TOWN OF MIDDLETOWN

From: Ron Wolanski, Town Planner

Date: November 4, 2024

Re: **Public Hearing** - Application of 72 Johnny Cake Hill, LLC for Development Plan Review for modification to a previously approved plan for construction of a 15,000 sq. ft. wholesale commercial use building, with associated parking, office space, landscaping, stormwater management, utilities, and associated site work, and including requests for waivers from certain design requirements of Section 521 of the Middletown Rules and Regulations Regarding the Subdivision and Development of Land. Property located on 72 Johnnycake Hill Road, Assessor's Plat 114, Lot 601.

PLANTING PLAN

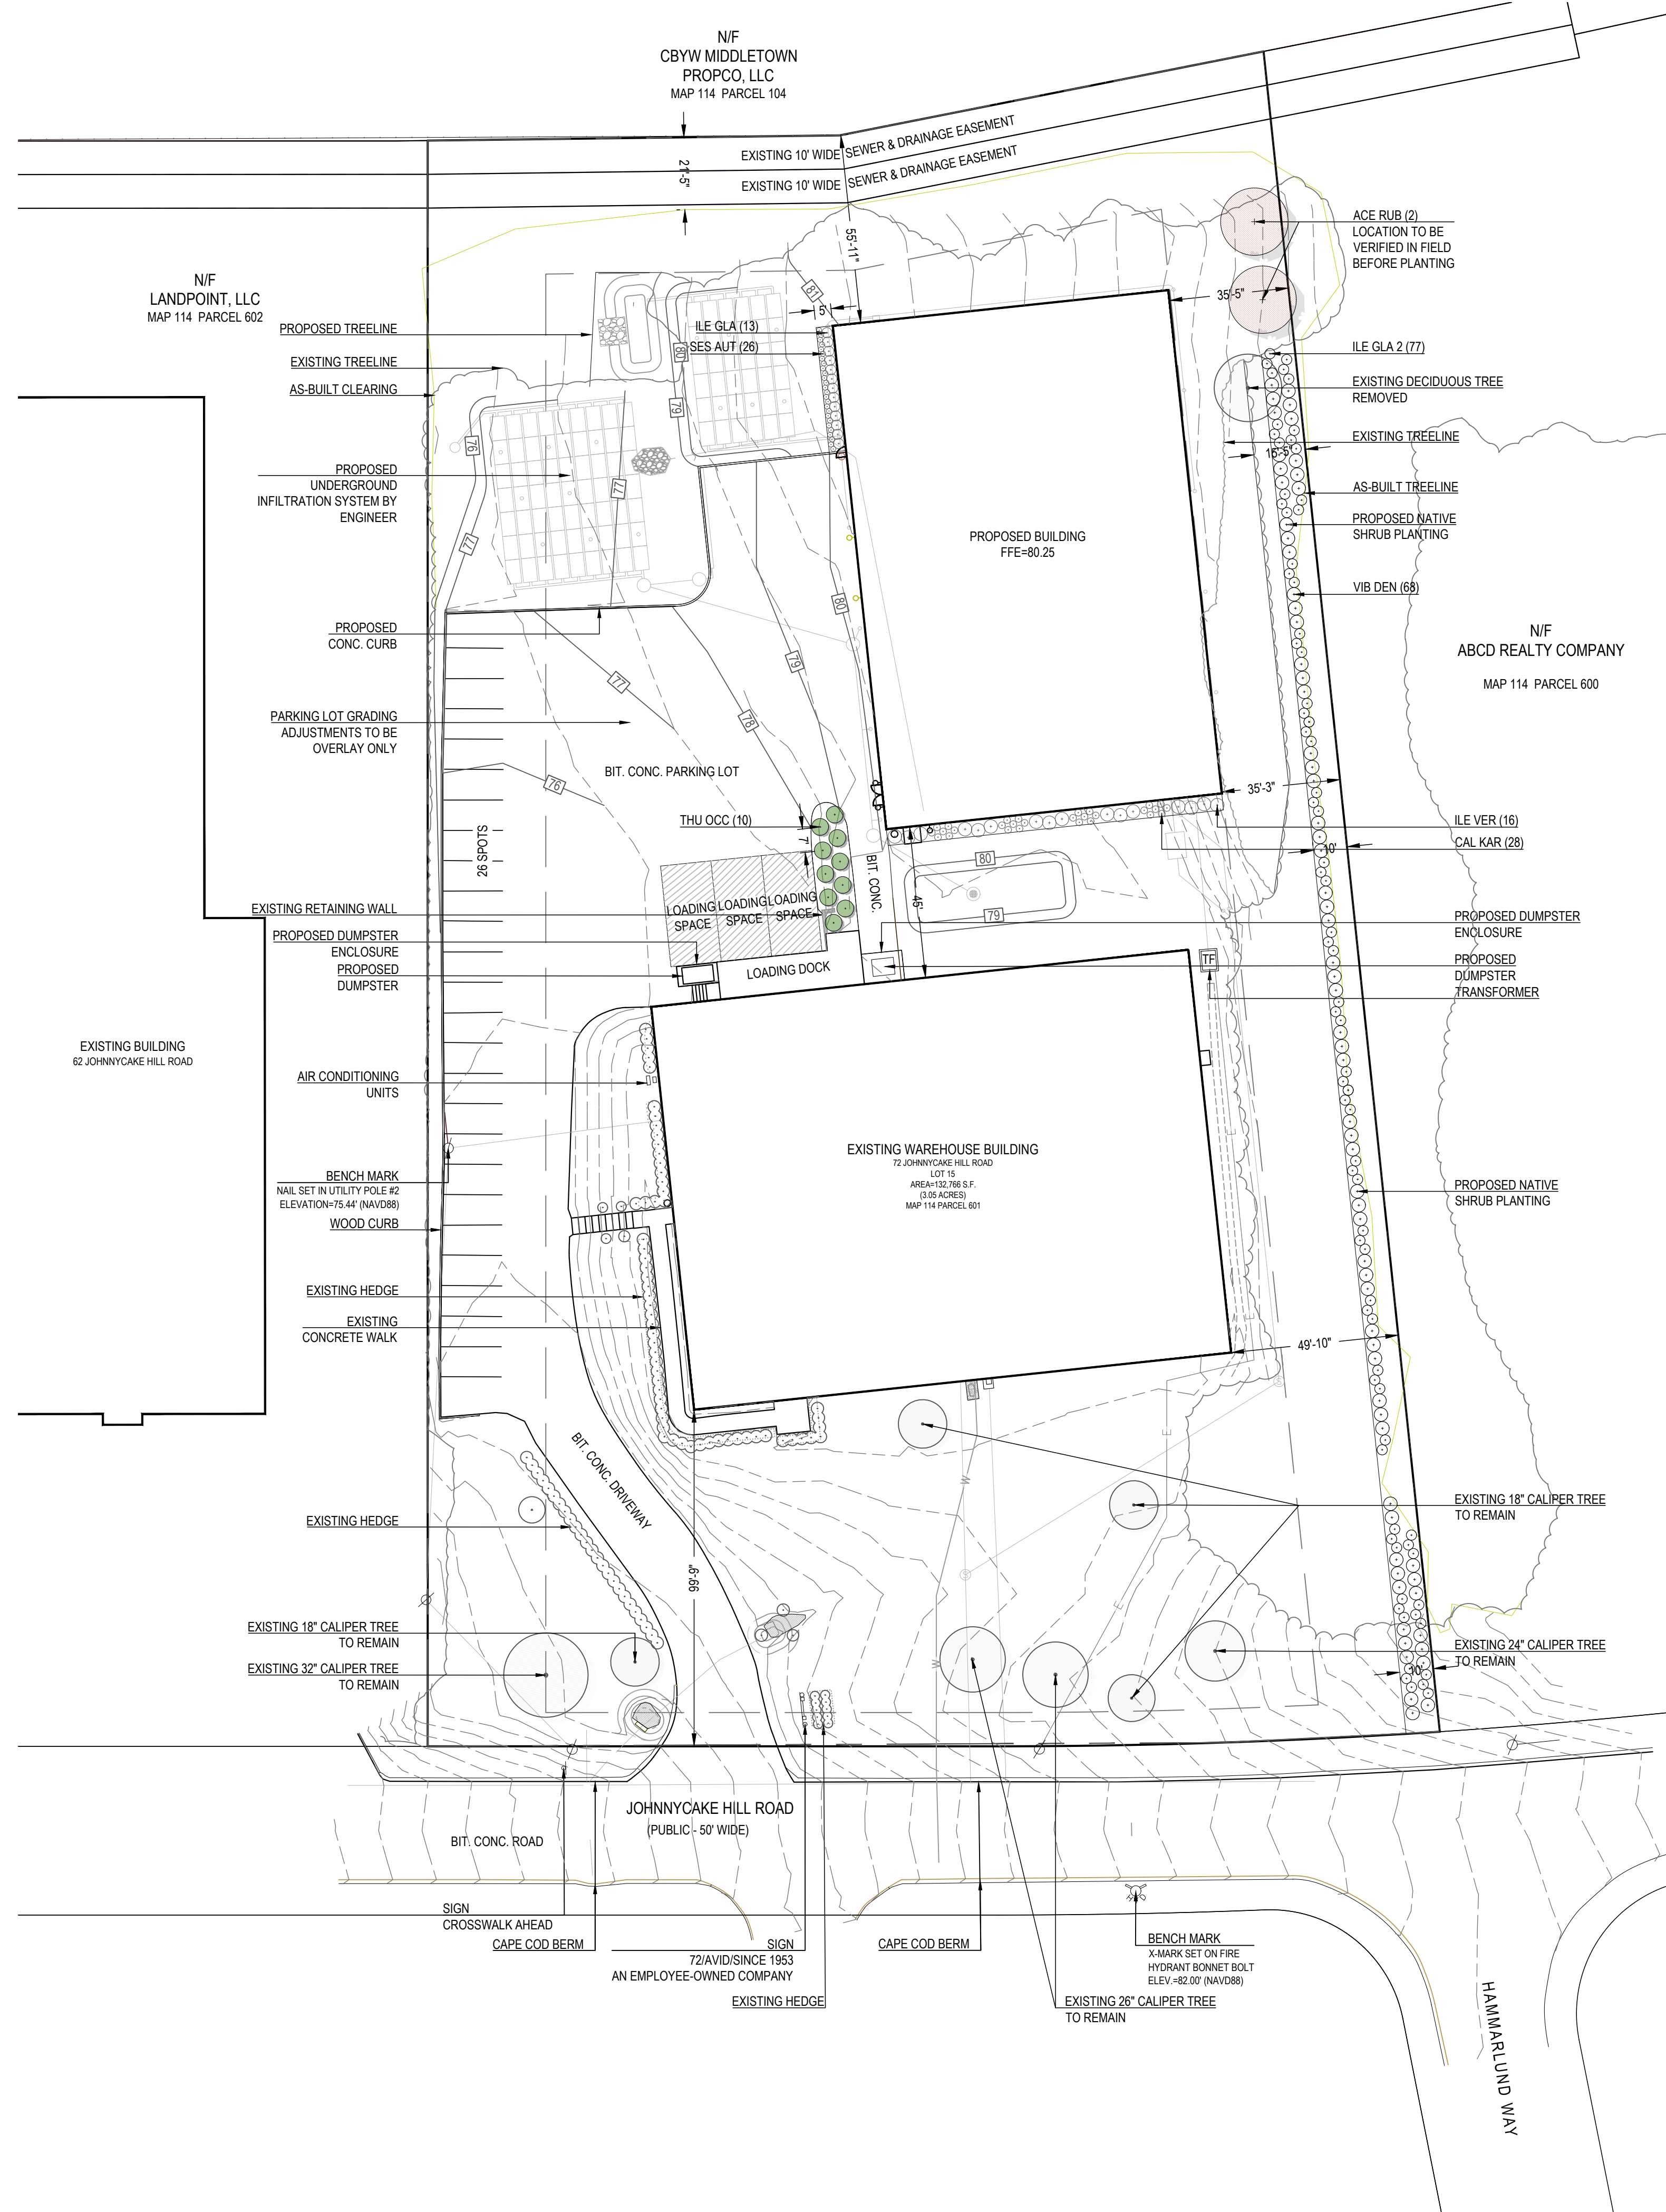
This item was continued to the November 13th meeting at the applicant's request. The applicant indicated that they are working to address concerns raised by an abutting property owner. As of this date no new information has been provided by the applicant. As previously discussed, it was confirmed that some vegetation that was to be retained on the property per the approved landscape plan for the project has been removed. The applicant provided the attached revised landscape plan to address this issue. It has been provided to the Tree Commission for review and comment.

Regulations, or must provide confirmation that the project is in compliance. The need for additional waivers will be determined upon submission of the revised landscape plan. The following waivers are based on the new building design and are in addition to waivers previously granted.
